**PETITION FOR CHANGE OF THE PROJECT DESCRIPTION IN THE FINAL
DECISION TO INSTALL AND OPERATE A STIRLING SOLAR DISH
PALOMAR ENERGY CENTER
(O1-AFC-24C)**

**SAN DIEGO GAS & ELECTRIC COMPANY
SAN DIEGO, CALIFORNIA**

CALIFORNIA ENERGY COMMISSION

SEMPRA ENERGY RESOURCES, LLC
 PALOMAR ENERGY PROJECT
 ESCONDIDO, CALIFORNIA
 CONCEPTUAL SITE LAYOUT
 SES SUNCATCHER PROJECT

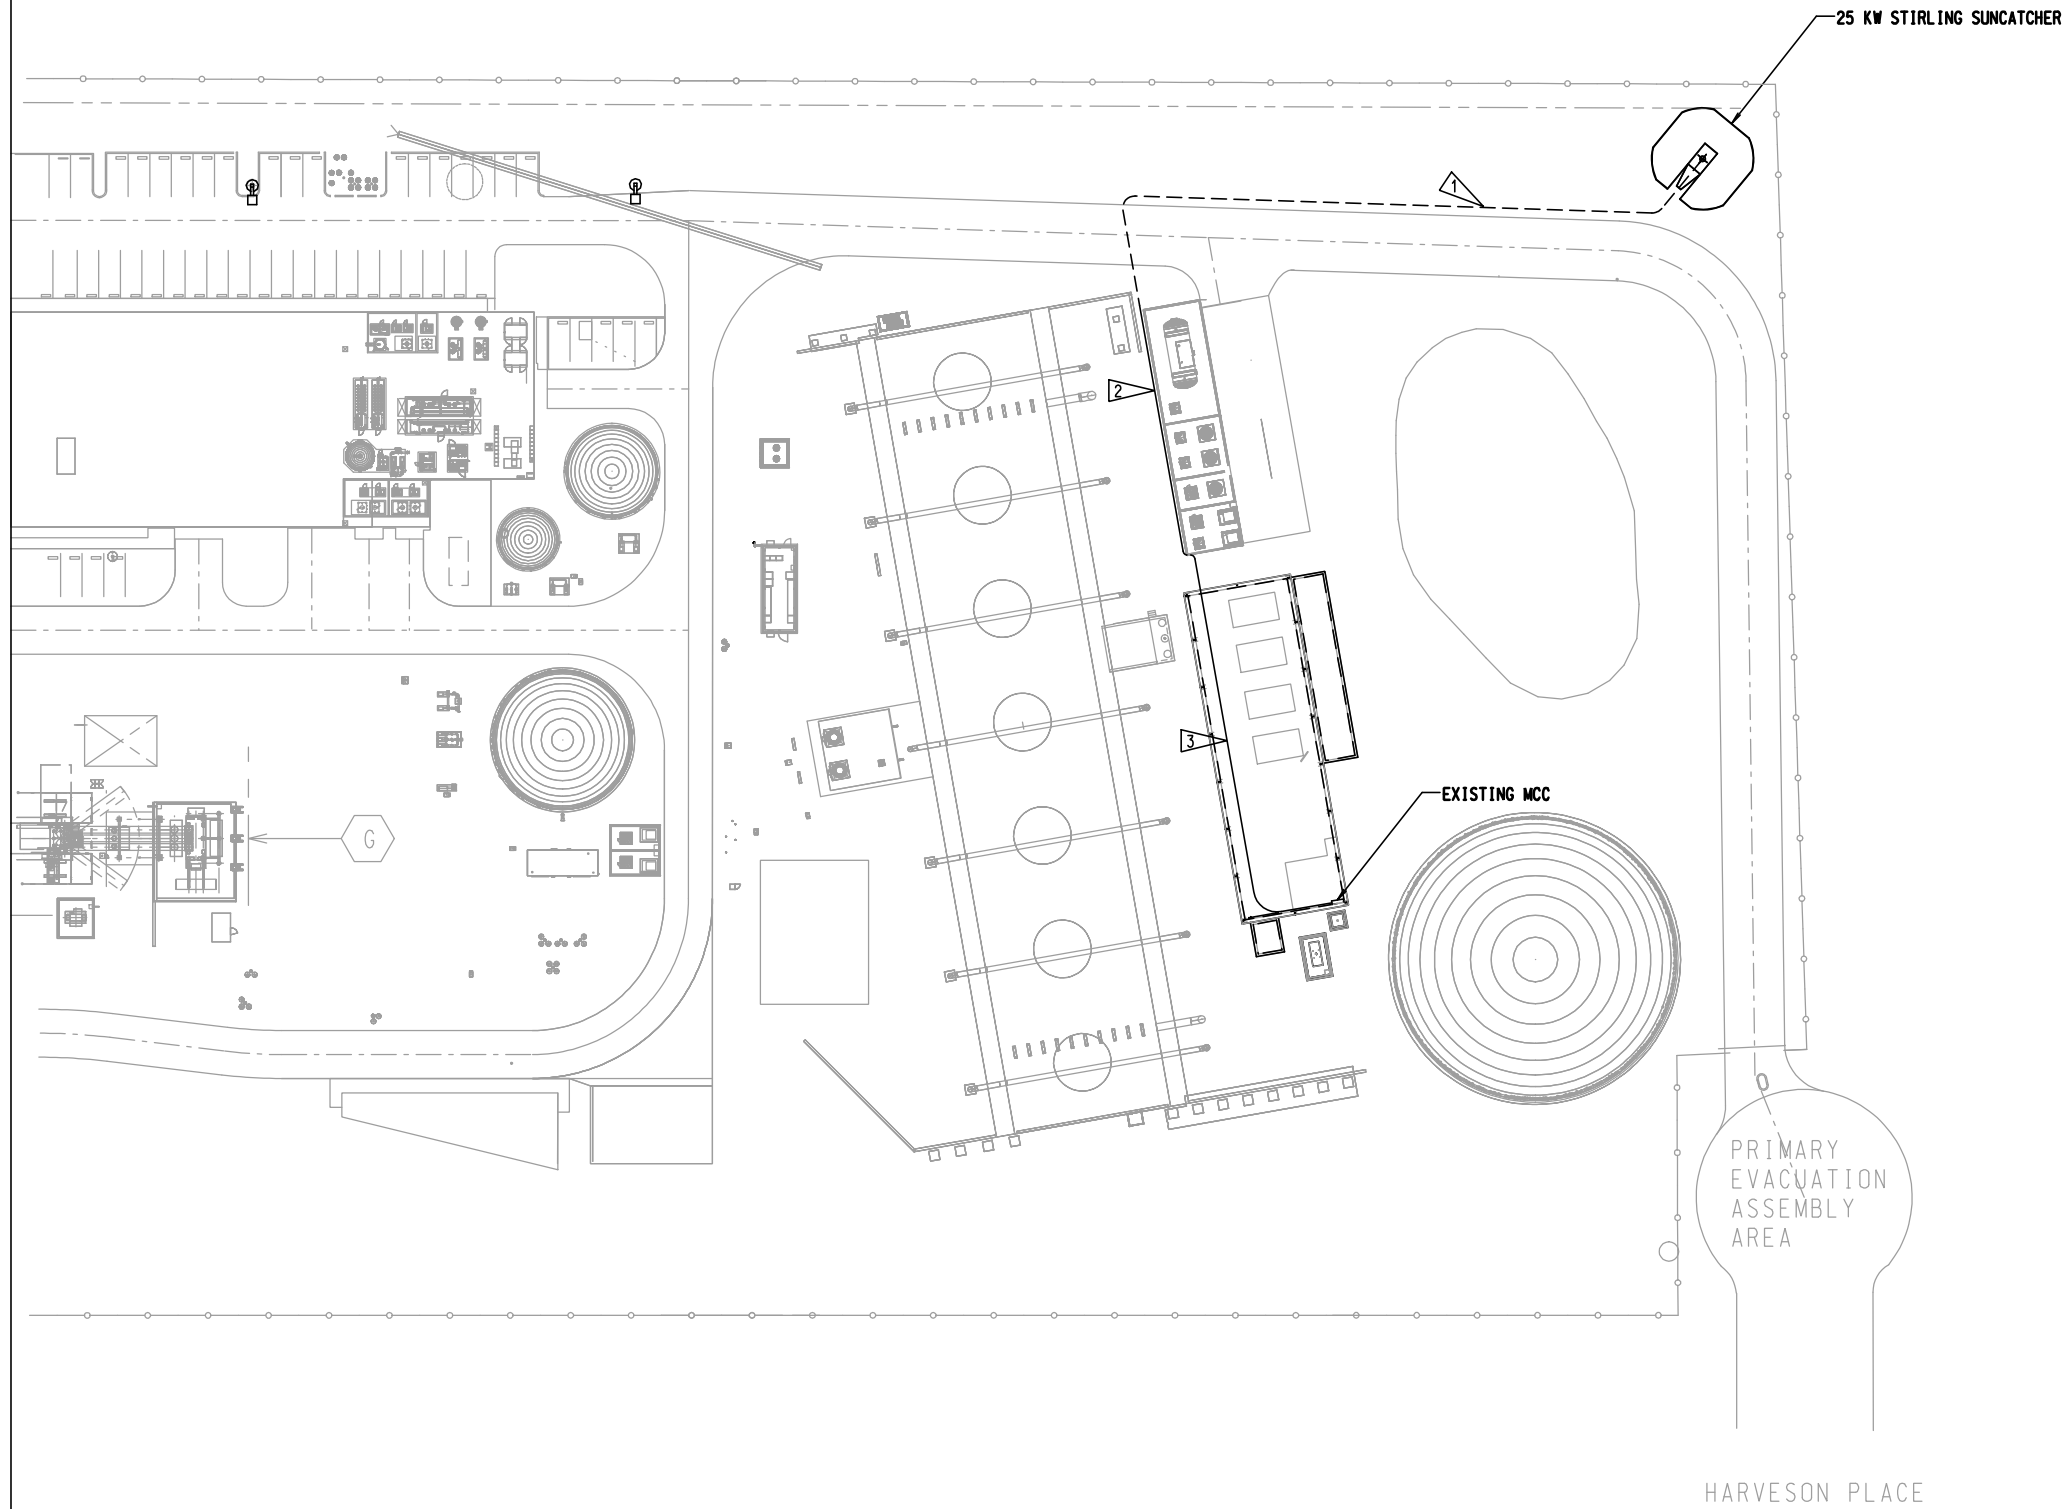
No changes are requested to the PEC Conditions of Certification or to any Verification. The proposed location for the SunCatcher is in the southeast corner of the property. A site plan, pictures of the unit, and visual simulations are included in Appendix 1. Installation of the SunCatcher will create minimal ground disturbance. A 24-inch diameter pole will be installed to support a 38-foot high by 40 foot in diameter dish composed of parabolic mirrors. These mirrors collect and focus solar energy onto the heat exchanger of the Power Conversion Unit (PCU) which powers the 2-cylinder Stirling

The SunCatcher will not be visible from most points outside the project site. The structure will not exceed the height of adjacent buildings. See Appendix 1 for site plans and visual renderings. The location of the unit will be in the southeast corner of the PEC site. It will be visible to the immediate east and south. The location of the unit is adjacent to and above the loading dock area and large driveway area of a commercial bakery. The other points from which the unit could be visible are to the west from Citracado Way from passing traffic for a few seconds and from the south from an undeveloped lot. Simulations from these locations are included in Appendix 1. The SunCatcher will appear similar to a large radio signal receiver and will add another feature to an existing large industrial site adjacent to commercial land uses. The unit will be observable by a very limited number of viewers. It will not be observable from any of the Key Observation Points identified in the course of the original licensing of the PEC. The unit will also meet surface treatment requirements condition of certification VIS-3. Paint color on any paintable surfaces will match the current plant structure paint color as approved by the Compliance Project Manager. The SunCatcher location will maintain ten feet of space from the property line per Condition VIS- 9. . Included in Appendix 2 is a glare and glint study that was conducted in the course of the proceeding to license the Imperial Valley Solar Project to address any visual impact from an aerial perspective. The glare was found to be minimal and is the same amount of glare typically seen from the reflection of a lake even from a field comprised of thousands of units.
